Subject: Exelon Nuclear Texas Holdings, LLC  
Victoria County Station Early Site Permit Application  
Response to Request for Additional Information Letter No. 14  
NRC Docket No. 52-042

02.05.01-22

**RAI 02.05.01-22:****Question:**

Figure 1. Geologic Features of the Gulf Coast Region with the Locations of the October 20, 2011 Mw 4.8 and November 12, 2011 Mw 3.3 Earthquakes

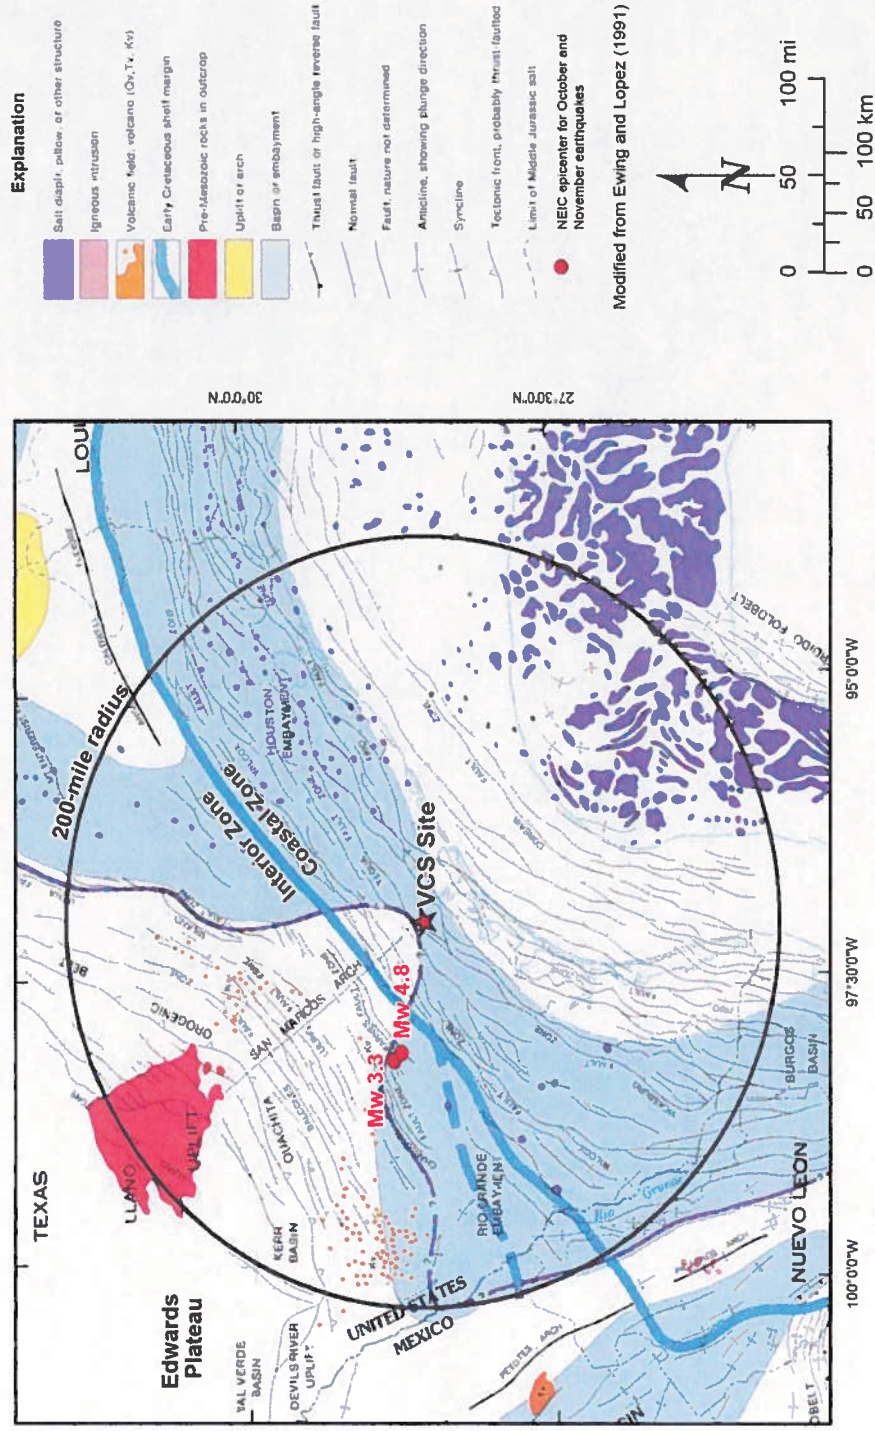
The USGS reported the Texas October 20, 2011 earthquake as a shallow (3 km, poorly constrained), Mw 4.8 earthquake with moment tensor solution of normal fault movement oriented northeast. The staff notes that both this earthquake and the November 12, 2011 Mw 3.3 event are located ~65 miles west of VCS, possibly near the surface expression of the Luling and Balcones fault zones. In order for staff to evaluate regional tectonic features within the 200 mile radius of VCS in its review of the VCS application and in support of 10 CFR 100.23, please provide the following:

Provide a discussion that examines the Texas earthquakes (October 20 and November 12, 2011) and implications for a VCS regional tectonic feature that might be considered a capable fault that originates within the Ouachita basement rock, beneath the Gulf Coast Coastal Plain sedimentary section. Include in your discussion the alternative possibilities that the Texas earthquake is induced or that it is a small seismic event on an active growth fault. Additionally, consider and discuss the possibility of an error in the location of the earthquake and the implications that a location error could have on all the above and related event fault and source interpretations.

The October Mw 4.8 and November Mw 3.3 earthquakes are located near Fashing, Texas, in an area of the Coastal Plain that has experienced several small to moderate earthquakes in the past approximately 40 years (Figure 1). As explained below, researchers studying past earthquakes in this area argue this seismicity is most likely induced by human activities (Davis, et al., 1995; Pennington, et al., 1986), and all information available suggests that the 2011 events are most likely induced by human activity as well.

The Mw 4.8 and 3.3 events are located along the western margin of the San Marcos arch adjacent to the Charlotte-Jourdanton fault zone (CJFS) and the Karnes fault zone (KFS) (Figures 1 and 2). As discussed in SSAR Subsection 2.5.1.1.4.3.3, the CJFS and KFS (along with the Mexia-Talco, Milano, and Mt. Enterprise-Elkhart Graben fault systems) are a part of the Mesozoic fault systems of the Gulf of Mexico region and are interpreted as being related to bodies of Jurassic salt at depth (SSAR Figures 2.5.1-11 and 2.5.1-12) (Ewing, 1991; Murray, 1961). In general, these fault systems are updip of, and sole into, salt pinchouts or welds, and motion on the faults is related to salt migration that formed the welds and pinchouts (Diegel, et al., 1995; Nelson, 1991).

The October 20, Mw 4.8, and November, 12 Mw 3.3, Texas earthquakes were located approximately 70 miles west-northwest of the VCS Site near Fashing, Texas (Figure 1). The U.S. Geological Survey National Earthquake Information Center (NEIC) reports that the October 20, 2011, Mw 4.8 event was located at 28.806°N, 98.147°W—approximately one mile north-northwest of the town of Fashing, Texas, with an uncertainty of 12 miles (19.3 km) and an estimated depth of 1.9 miles (3 km) (with  $\pm 1.9$  miles [3.1 km] uncertainty; Figure 2) (USGS, 2011b). The double-couple focal mechanism for the Mw 4.8 event includes a generally northeast-oriented (053° and 241°) solution dipping either 72° south-southeast or 18° north-northwest.

**Figure 3. Location of Major Gas Field in the Fashing Area**

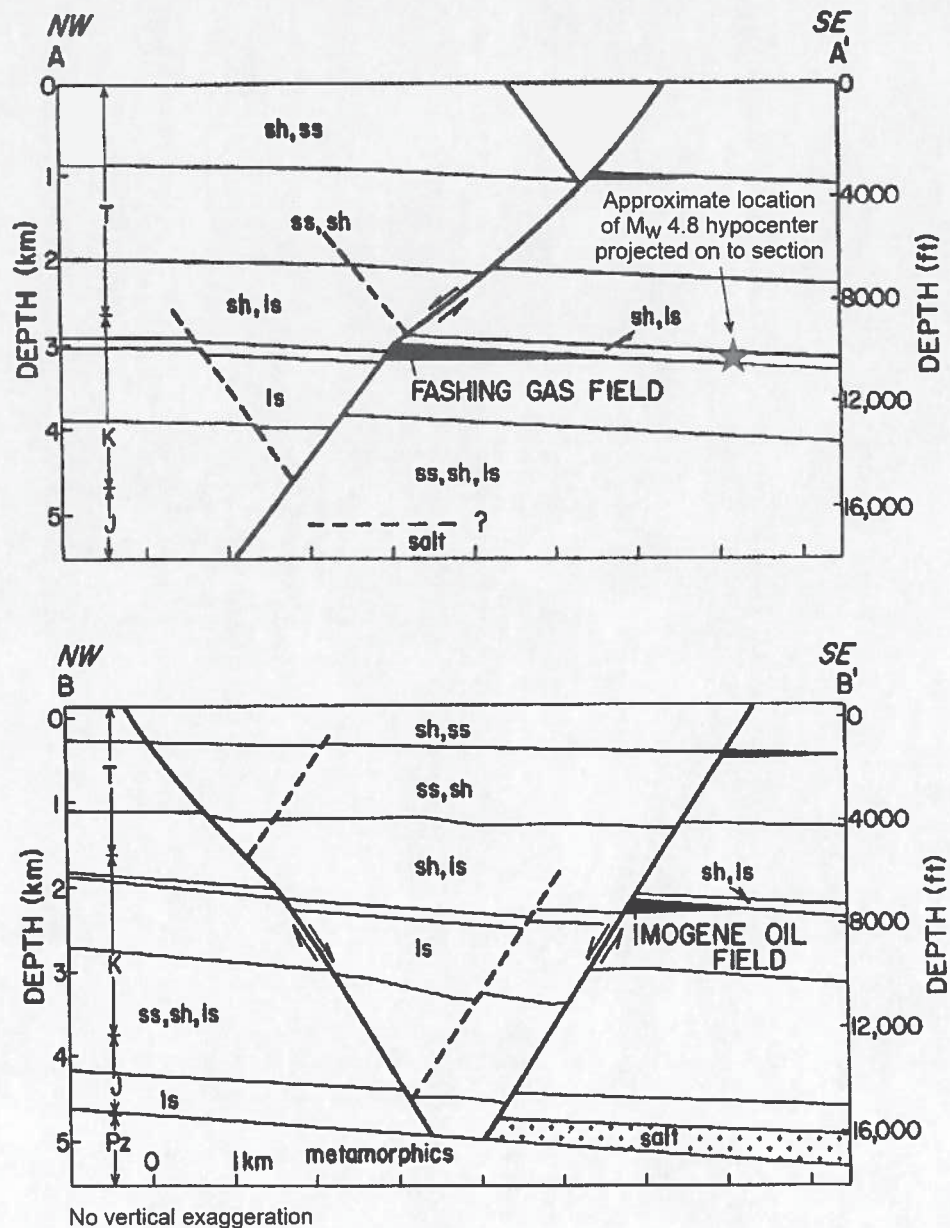
***Question 2: Include in your discussion the alternative possibilities that the Texas earthquake is induced or that it is a small seismic event on an active growth fault.***

Seismicity can be induced (or caused by human-related activities) through primarily two activities: 1) construction of large reservoirs or 2) fluid extraction or injection. The October and November earthquakes are not located near a large surface-water reservoir. The closest such reservoir is more than 20 miles southwest (Figure 3). Thus, these earthquakes were most likely not related to a surface-water reservoir.

The October 20, 2011, Mw 4.8 earthquake is located near the southeastern edge of the Fashing gas field, and the November 11, 2011, Mw 3.3 event is located near the northwest edge of the field (Figure 3). Given the spatial association of the Mw 4.8 October 20, 2011, event with the horizontal and vertical position (3 km depth) of the gas field, coupled with the 1993  $m_{BLg}$  4.3 Fashing earthquake and subsequent publications suggesting an induced earthquake mechanism (Davis, et al., 1995), it is probable that the October 20, 2011, earthquake was induced by gas field activity and likely reactivated the nearest growth fault (i.e. the KFS; see results summarized in Table 1). At the same time, it cannot be scientifically precluded that the October 20, 2011, event resulted from natural earthquake stress relief along shallow growth faults overlying the Paleozoic basement rocks (i.e., the KFS). However, the spatial coincidence with the Fashing Gas Field and the previous occurrence of withdrawal-induced seismicity in the epicentral area, based on consensus from review of the peer-reviewed literature, suggests that the most likely cause is fluid withdrawal in the subsurface (Table 1).
